REGIONAL REVIEW FINDING

TO: Chairwoman Nicole Love Hendrickson, Gwinnett County
ATTN TO: Catherine Long, Long Range Planning Manager, Gwinnett County
FROM: Mike Alexander, Director, ARC Center for Livable Communities
RE: Development of Regional Impact (DRI) Review

Name of Proposal: **5030 Sugarloaf DRI 3705**
Submitting Local Government: Gwinnett County
Date Opened: August 11, 2022 **Date Closed:** September 2, 2022

TITLE
DRI SITE PLAN

SHEET NUMBER
DRI-01

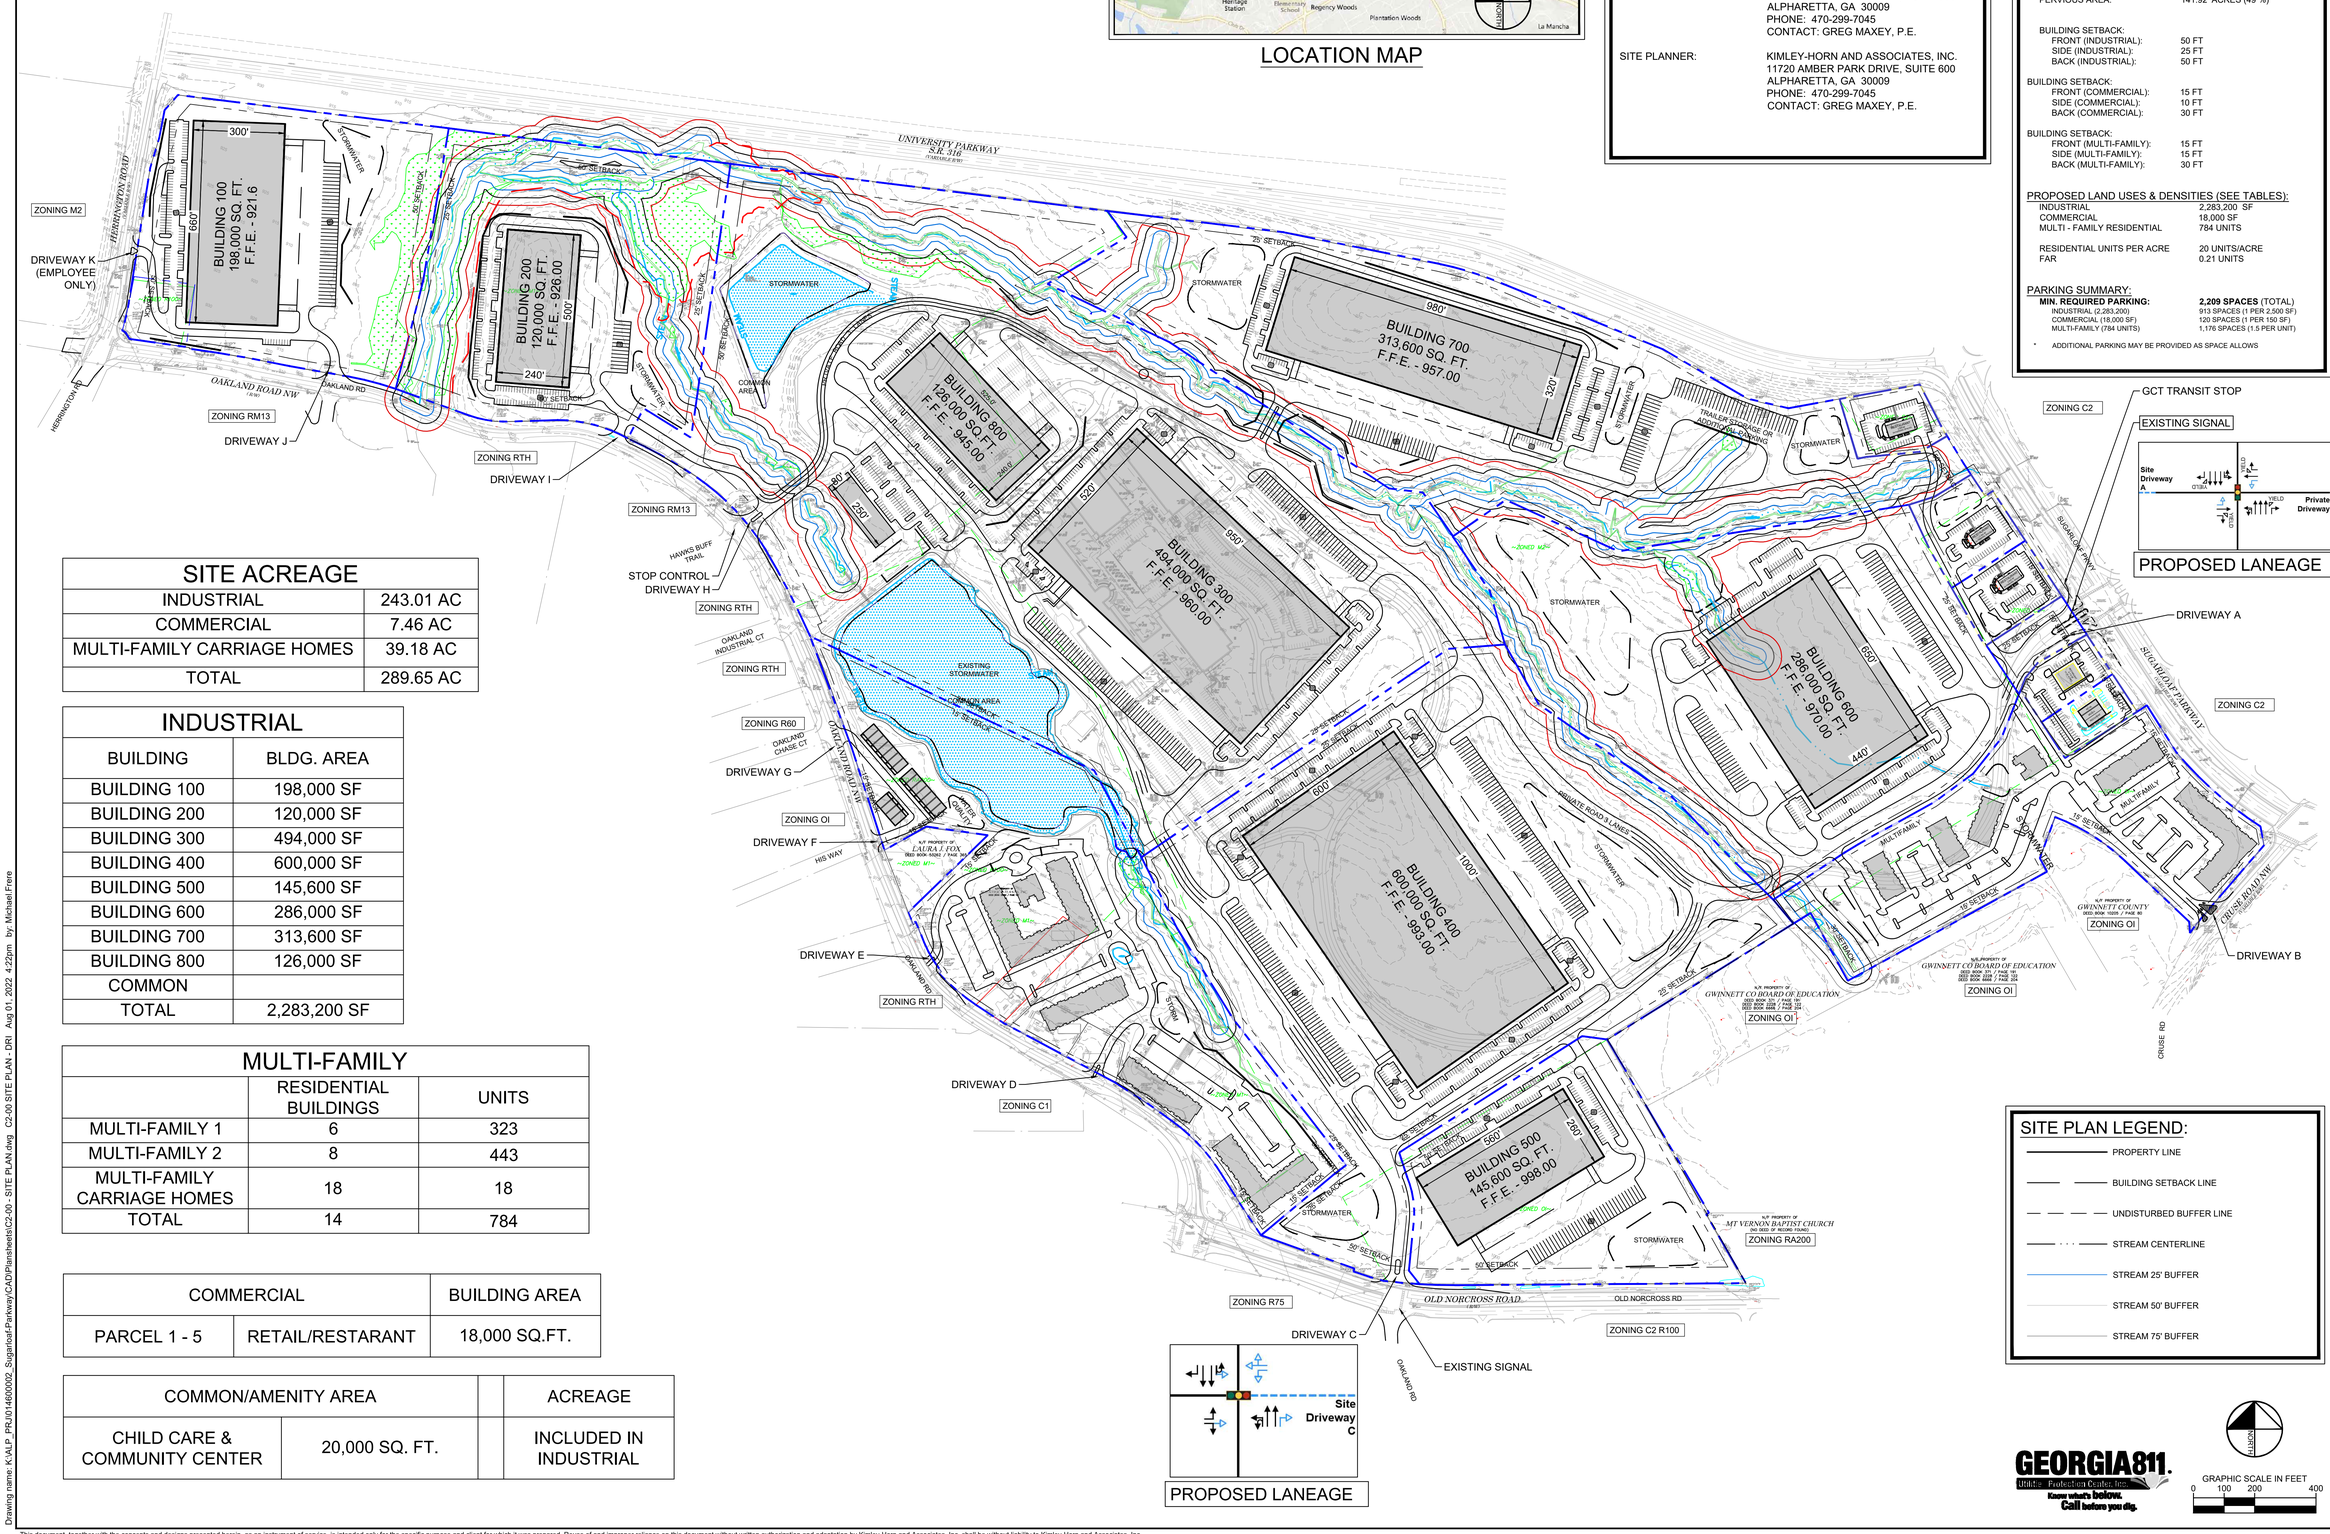
The placement of 5 restaurant out-parcels with drive through lanes surrounded by surface parking with limited pedestrian access immediately adjacent to a Gwinnett County Transit stop – which only averaged 4 boardings/alightings a day in 2021 – is inconsistent with regional and County transit and multi-modal transportation policies.

The project provides 784 multi-family housing units which is strongly supportive of regional housing policies; however, the pedestrian network serving the housing is not well developed and the location of the housing away from the Gwinnett County Transit stop does not encourage transit use. Ideally the housing could be shifted closer to, and the drive through restaurants shifted away from, the bus transit stop.

The main project entrance on Sugarloaf Parkway is an existing driveway designed to facilitate automobile through flow with separate right turn in and out lanes that require a yield to pedestrians rather than a stop; this driveway entrance should be revised to provide a safe pedestrian crossing to allow multi-family residents to easily access the Gwinnett County Transit stop just to the north.

Multiple intrusions by buildings, roadways, and parking areas into protected stream buffers are proposed and may require county or state variances.

No internal pedestrian/bicycle system is proposed which is not in keeping with minimal walkability and multi-modal transportation requirements and policies; basic bicycle and pedestrian systems are as integral a part of a project as roadway systems and should not be considered as optional.

A planned Lee Daniel Creek spur trail – part of the Gwinnett Countywide Trails Master Plan – ends on the south side of Oakland Road between Buildings 100 and 200 which offers a significant opportunity to advance multi-modal transportation policies by extending the trail through the site to connect to the project's substantial housing components.

A total of new 2,209 surface parking spaces – the minimum allowed – are proposed which is supportive of multi-modal transportation policies; provision of adequate tree canopy in these lots and the use of high albedo, pervious paving materials would be supportive of regional environmental and heat mitigation policies.

Site plan doesn't look to address how to manage pedestrian/residential/truck traffic adequately enough.

Both the USGS coverage for the project area and the project site plan show an unnamed tributary to Lee Daniel Creek crossing the western portion of the property, along with a perennial stream and an intermittent stream running southeast to northwest across the property to the unnamed tributary. The site plan also shows two short branches off the intermittent stream. The site plan shows the County 50-foot stream buffer and 75-foot impervious setback, as well as the State 25-foot Sediment and Erosion Control buffer on all streams. Intrusions into the buffer are shown on the plan – Building 600 and trailer storage for Building 700 over portions of two branches off the unnamed stream shown as intermittent on USGS coverage as well as several road crossings. Other proposed structures and parking areas are shown as approaching the edge of the buffers. Any proposed intrusions into the buffers not exempted under the County ordinance may require a variance from the County. Intrusions into the State 25-foot Sediment and Erosion Control buffer may also require variances. Any unmapped streams on the property may be subject to the County and State buffers. Any unmapped waters of the state will also be subject to the State 25-foot Sediment and Erosion Control buffer.

The project's alignment with Regional Center growth policies could be substantially furthered through the dedication of some accessible conservation space; the replacement of the drive through restaurants adjacent to the transit stop with transit supportive uses; the provision of a robust internal sidewalk, bike, and trail system connecting to the planned external trail system; and the alteration of the balance of uses to reduce the non-compatible industrial/warehouse use and increase the amount of office, retail, and housing uses appropriate for Regional Centers. Gwinnett County leadership and staff, along with the applicant team, should collaborate closely to ensure optimal responsiveness to the needs of nearby local governments, neighborhoods, and natural systems.
